AMENDMENT OF SOLICITATION/MODIFICATION OF CONTRACT			1. CONTRACT ID CODE	PAGE 1 OF 9 PAGES
2. AMENDMENT/MODIFICATION NO. AMENDMENT NO. 0006		3. EFFECTIVE DATE 09/09/10	4. REQUISITION/PURCHASE REQ. NO.	5. PROJECT NO. (If applicable) 10-0216
6. ISSUED BY CODE		CODE mks	7. ADMINISTERED BY (If other than Item 6) CODE See Item 6	
Officer in Charge of Construction MCI-East 1005 Michael Road Camp Lejeune, NC 28547-2521				
8. NAME AND ADDRESS OF CONTRACTOR (No., street, county, State and ZIP Code)			(X)	9A. AMENDMENT OF SOLICITATION NO. N40085-10-R-0216
			X	9B. DATED (SEE ITEM 11) 08/26/10
				10A. MODIFICATION OF CONTRACT/ORDER NO.
				10B. DATED (SEE ITEM 11)
CODE	FACILITY CODE

10-0216, Athletic Field Improvements, DDESS

TITLE IX ATHLETIC IMPROVEMENTS MCB CAMP LEJEUNE, NC

ELECTRICAL SITE PLAN

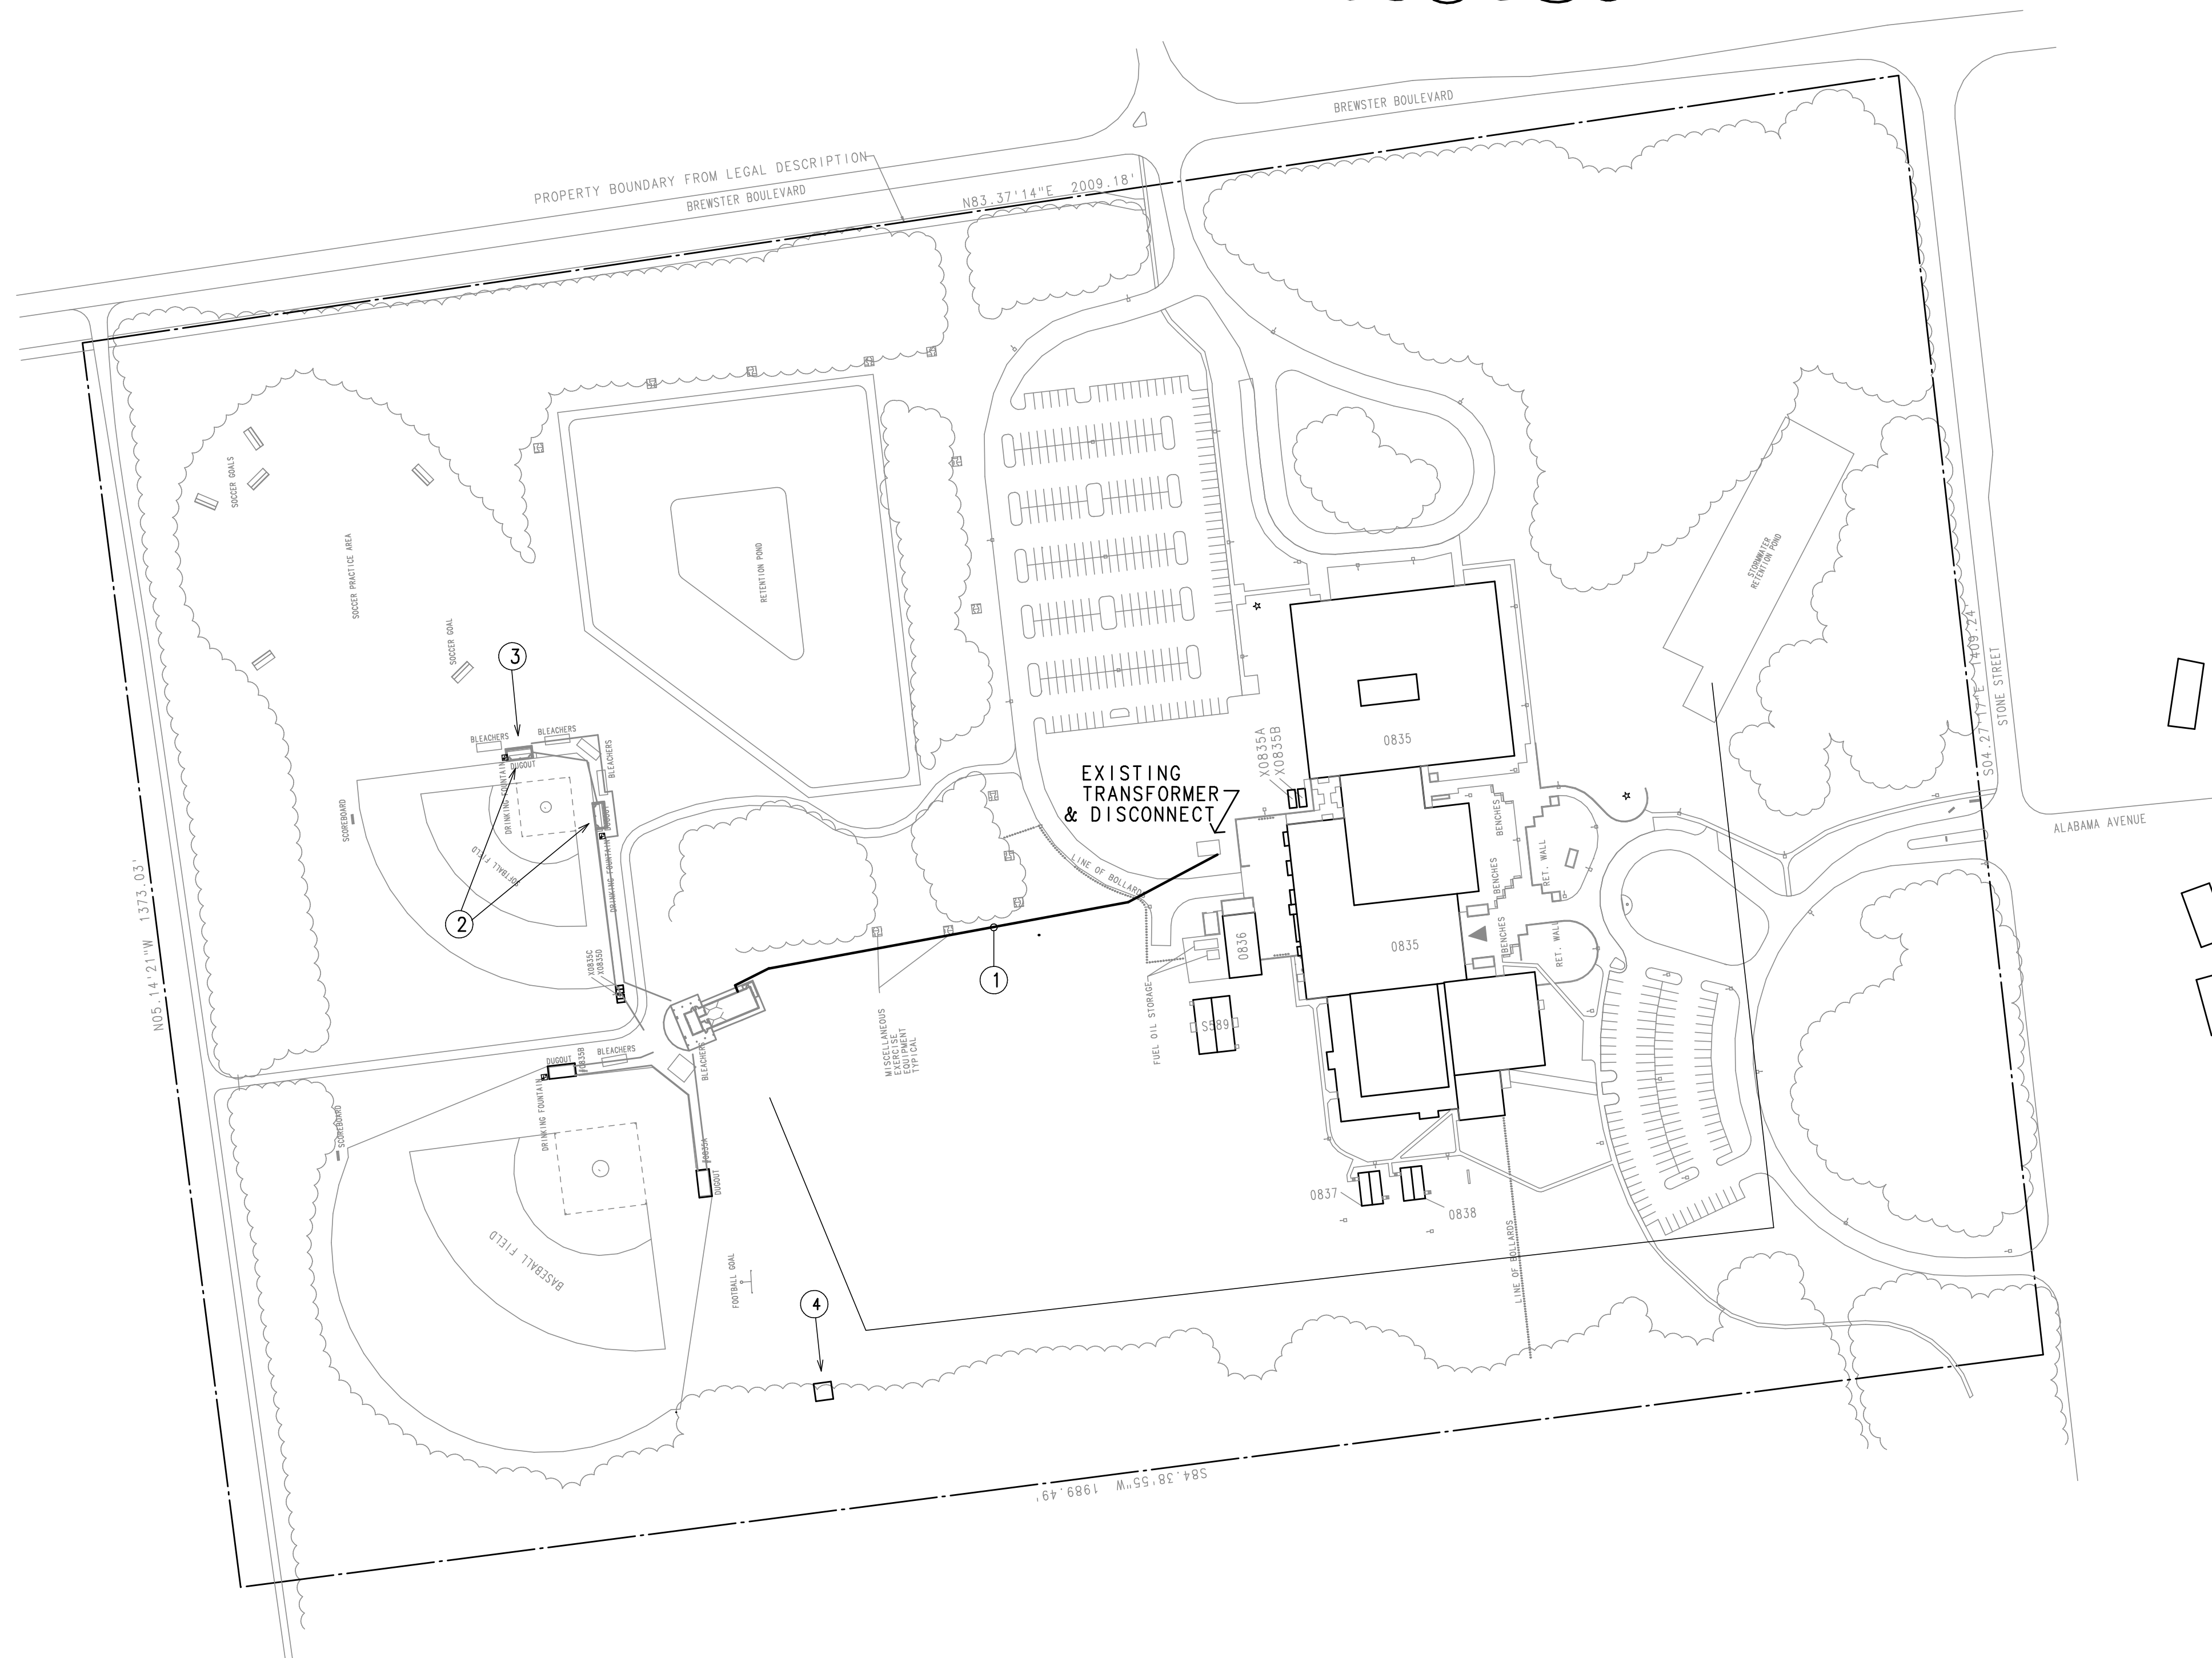
D. SHEET E-401

1. Note 4 was modified add lighting to Lift Station and to add a circuit to the RPZ enclosure for freeze protection.

- ① CONNECT NEW SERVICE FOR NEW BUILDING TO SECONDARY OF EXISTING TRANSFORMER.
- ② PROVIDE AND INSTALL WEATHERPROOF, INUSE, DEDICATED RECEPTACLES IN EACH SOFTBALL DUGOUT. SEE SHEET E-301.
- ③ PROVIDE AND INSTALL WEATHERPROOF, INUSE, DEDICATED RECEPTACLE AT FUTURE SOFTBALL BATTING CAGE. PROVIDE 3' ABOVE GROUND STEEL TUBE COLUMN TO MOUNT RECEPTACLE TO. COORDINATE LOCATION WITH SCHOOL
- ④ CONNECT NEW PUMP STATION TO M-7. MOUNT TYPE A LIGHT FIXTURE ON EAST AND WEST FENCE RAIL OR POST ON A CAST BOX. CONNECT THROUGH FUSED NEMA 3R DISCONNECT TO SECONDARY OF DRY TYPE TRANSFORMER. EXTEND A 120 VOLT FUSED CIRCUIT TO HEATER IN RPZ ENCLOSURE.

CORPS OF ENGINEERS
TYPE: SF11

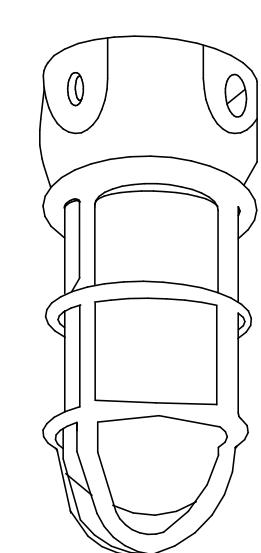
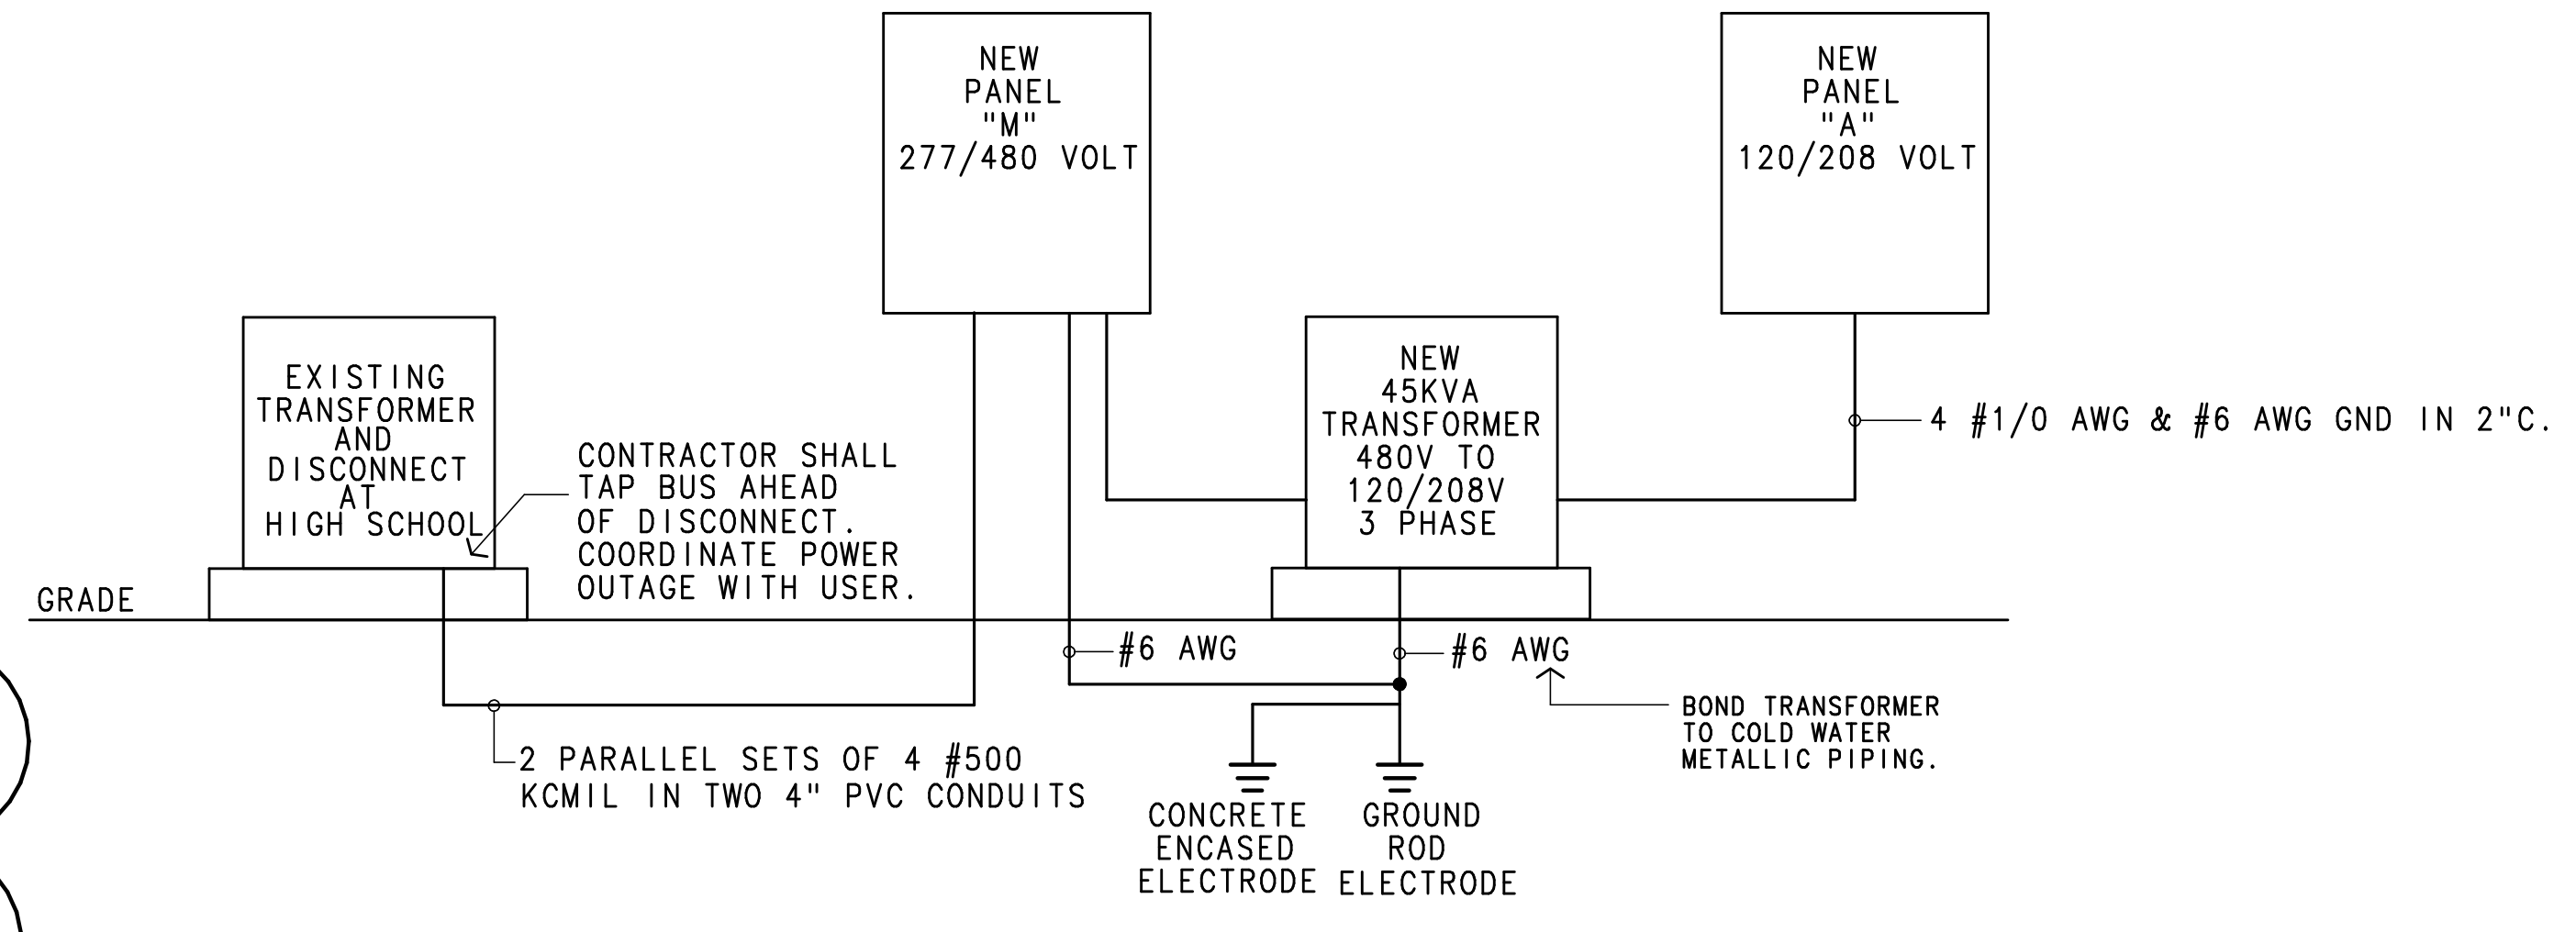
C. SHEET E-501

1. Fixture SF11 detail was added for the Type "A" fixture that is indicated to be installed on the Lift Station fence. Fixture was also added to Light Fixture Schedule.

SURFACE MOUNTED COMPACT FLUORESCENT
VAPOR TIGHT JELLY JAR WITH WIRE GUARD
MOUNTED TO CAST BOX ON INSIDE OF FENCE
